Errata Sheet

March 30, 2001 / Release 1.0

Device: SAB-C165-LM, -LF
SAF-C165-LM, -LF
SAB-C165-L25M, -L25F
SAF-C165-L25M, -L25F
SAB-C165-LM3V, -LF3V
SAF-C165-LM3V, -LF3V

Stepping Code / Marking: ES-HA, HA

7. Timing of flag SSCTIR (SSC Transmit Interrupt Request)

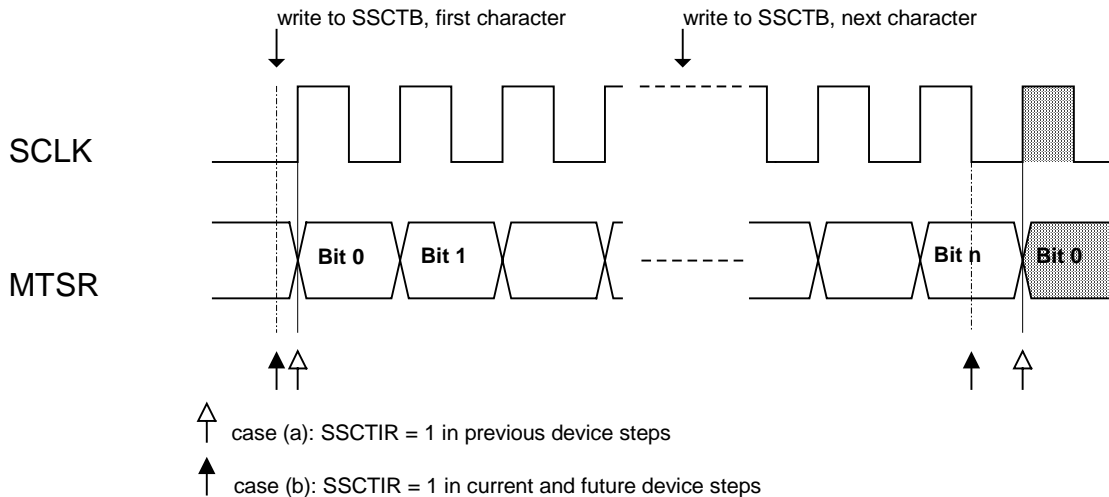
In master mode, the timing of SSCTIR depends on the device step as follows:

- (a) before step **FA** (internal stepping F11) of the **C165**, flag SSCTIR is set to '1' synchronous to the shift clock SCLK 1/2 bit time before the first latching edge (= first shifting clock edge when SSCPH = 0). When SSCTB is written while the shift register is empty, the maximum delay between the time SSCTB has been written and flag SSCTIR=1 is up to 1/2 bit time.

- (b) beginning with step **FA** (internal stepping F12) of the **C165**, when SSCTB has been written while the transmit shift register was empty (and the SSC is enabled), flag SSCTIR is set to '1' directly after completion of the write operation, independent of the selected baud rate. When the transmit shift register is not empty when SSCTB was written, SSCTIR is set to '1' after the last latching edge of SCLK (= 1/2 bit time before the first shifting edge of the next character). See also e.g. C167CR User's Manual V3.1, p. 12-5.

The following diagram shows these relations in an example for a data transfer in master mode with SSCPO = 0 and SSCPH = 0. It is assumed that the transmit shift register is empty at the time the first character is written to SSCTB:

Typically, in interrupt driven systems, no problems are expected from the modified timing of flag SSCTIR. However, when flag SSCTIR is polled by software in combination with other flags which are set/cleared at the end or at the beginning of a transfer (e.g. SSCBSY), the modified timing may have an effect.

Another situation where a different system behaviour may be noticed is the case when only one character is transferred by the PEC into the transmit buffer register SSCTB. In this case, 2 interrupt requests from SSCTIR are expected: the 'PEC COUNT = 0' interrupt, and the 'SSCTB empty' interrupt.

- in the **FA** (and newer) steps of the **C165**, the second interrupt request ('SSCTB empty') is always **systematically** generated before the first one ('PEC COUNT = 0') has been acknowledged by the CPU, such that effectively only **one interrupt request** is generated for two different events.

- before step **FA** of the **C165**, when the PEC transfer is performed with sufficient margin to the next clock tick from the SSC baud rate generator, and no higher priority interrupt request has occurred in the meantime, the 'PEC COUNT = 0' interrupt will be acknowledged before the 'SSCTB empty' interrupt request is generated, i.e. **two interrupts** will occur based on these events. However, when the PEC transfer takes place relatively close before the next clock tick from the SSC baud rate generator, or a higher priority interrupt request has occurred while the PEC transfer is performed, the 'PEC COUNT = 0' interrupt may not be acknowledged before the 'SSCTB empty' interrupt request is generated, such that effectively only **one interrupt request** will be generated for two different events.

In order to achieve a defined and systematic behavior with all device steps, the SSC receive interrupt, which is generated at the end of a character transmission, may be used instead of the SSC transmit interrupt.
